**TOWN OF PORTOLA VALLEY
ARCHITECTURAL AND SITE CONTROL COMMISSION (ASCC)
Monday, September 28, 2015
7:00 PM – Regular ASCC Meeting
Historic Schoolhouse
765 Portola Road, Portola Valley, CA 94028**

MEMORANDUM

RE: Architectural Review for Addition and Remodel, File # 17-2015, 15 Adair Lane, Low Residence

A1

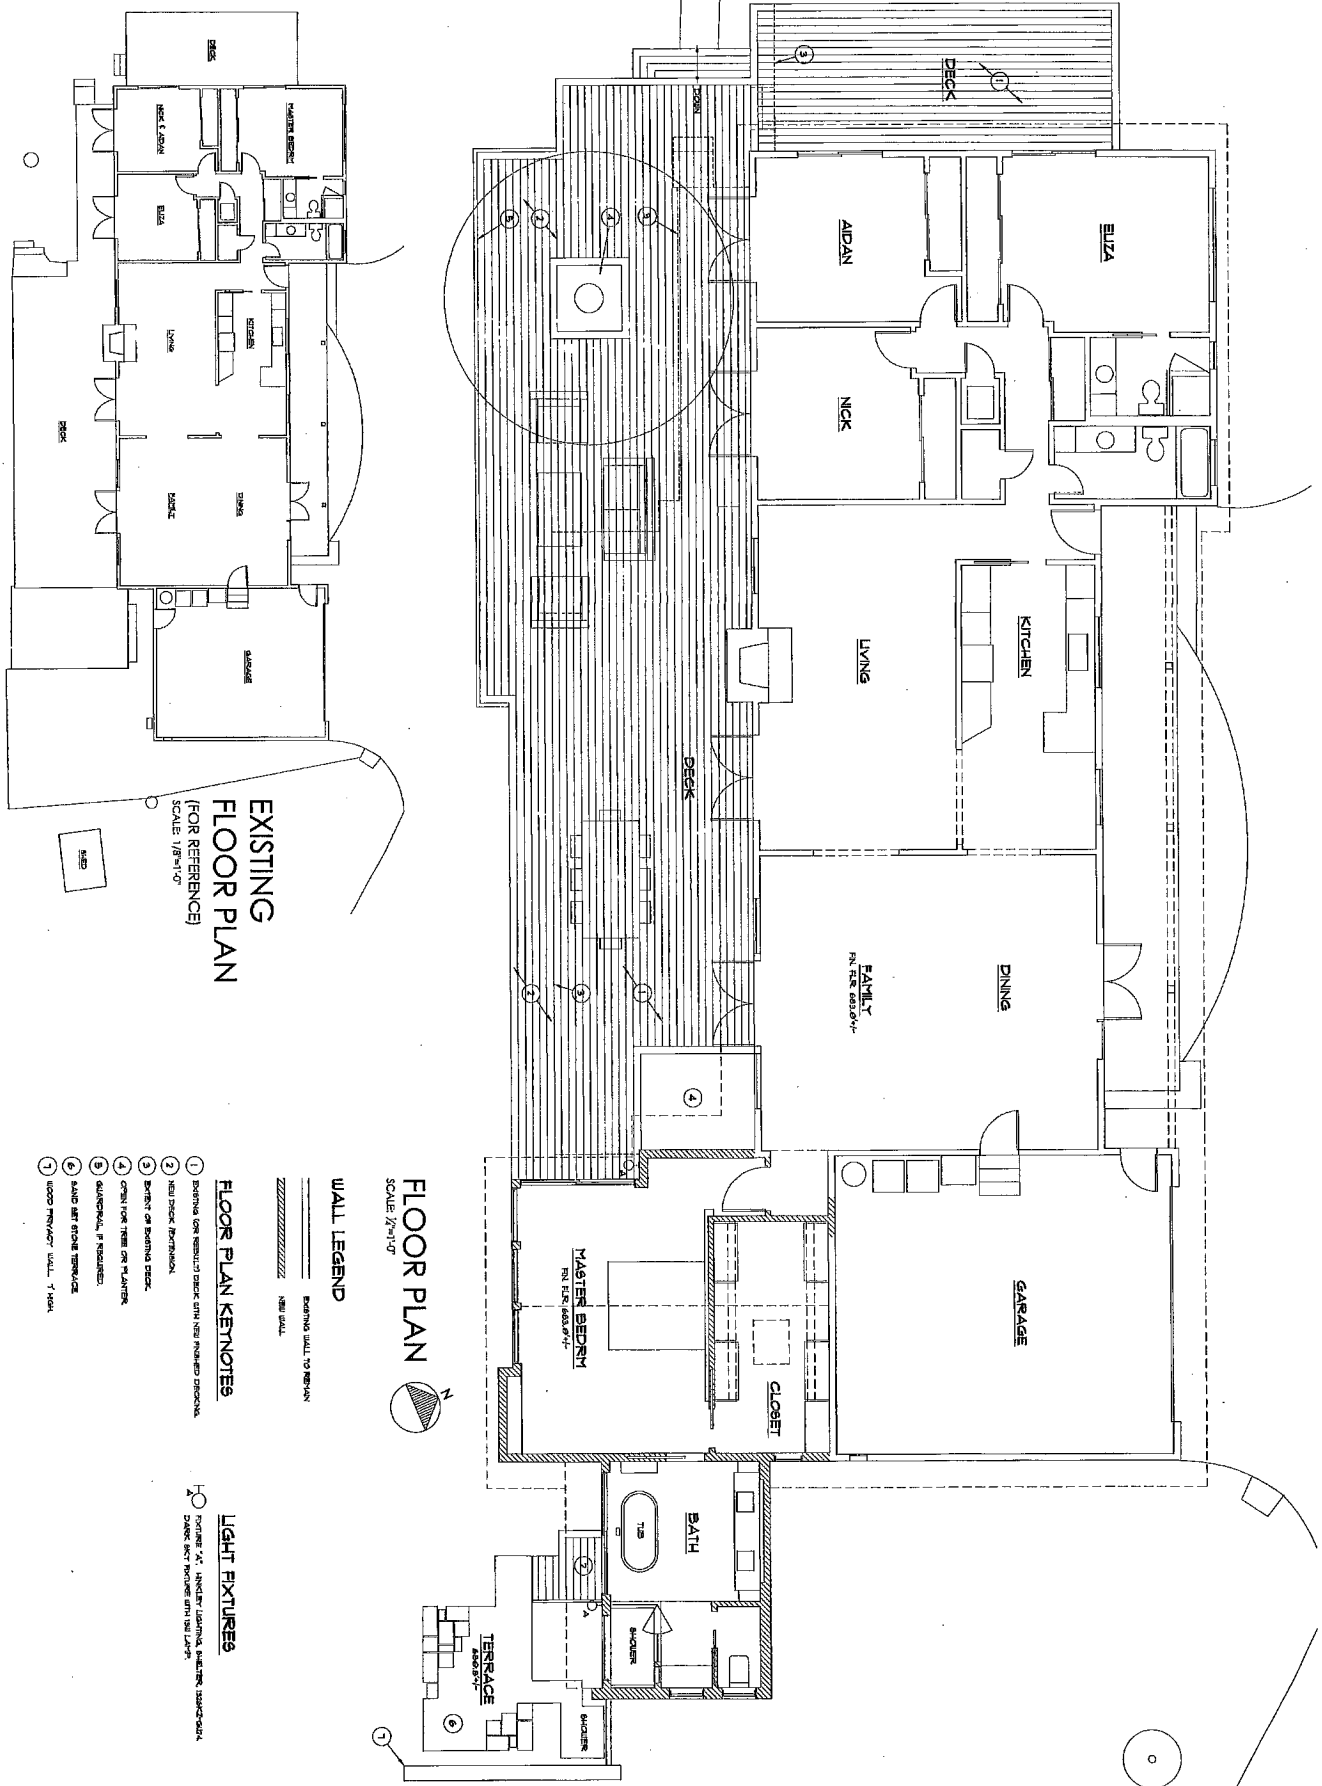
Proposed exterior lighting is shown on Sheet A2, and the cut sheets are in Attachment 5. The plan proposes two 13-watt CFL sconces, with one located at the bedroom sliding door and the other located at the bathroom sliding door. The fixture and proposed locations appear to be in general compliance with Town guidelines. Any non-compliant exterior lighting fixtures will need to be removed with the project.

There is no new landscape planting or fencing proposed with the project. Two Italian cypress and one fir tree will be removed. The existing oleanders adjacent to the new addition are proposed to remain.

There is existing non-conforming fencing located along the front and side property lines. The fencing near the front property line is located behind a large hedge within the Town's right of way, and both the hedge and the fencing should be removed. Six-foot wood and wire fencing along the side property lines, but within the 50-foot front setback should also be brought into compliance with Town regulations that permit only four-foot high horse fencing within this area. Any new proposed fencing shall comply with Town regulations.

Additionally, there is an existing non-conforming driveway entry gate and columns. There is no record of permit for the gate, and it is unknown when the gate/columns were built. The gate and columns exceed the four-foot maximum height limit and are located approximately seven feet from the front property line, whereas a conforming gate would be located at least 25 feet from the front property line. As the gate and columns were not permitted and do not comply with Town regulations, they should be removed or relocated.

2. The existing fencing and hedge located within the Town's right of way shall be removed. Non-compliant fencing on side property lines shall be removed and/or brought into compliance with Town fencing regulations. Any new fencing shall comply with Town regulations.

3. The existing entry gate and columns shall be removed. Any new entry gate and columns shall comply with Town regulations and is subject to review by the ASCC.

5. Any non-compliant exterior lighting (including up-lighting, lights hung in trees, ornamental landscape lighting, and fixtures with clear glass) on the home and on site shall be removed prior to final inspections.
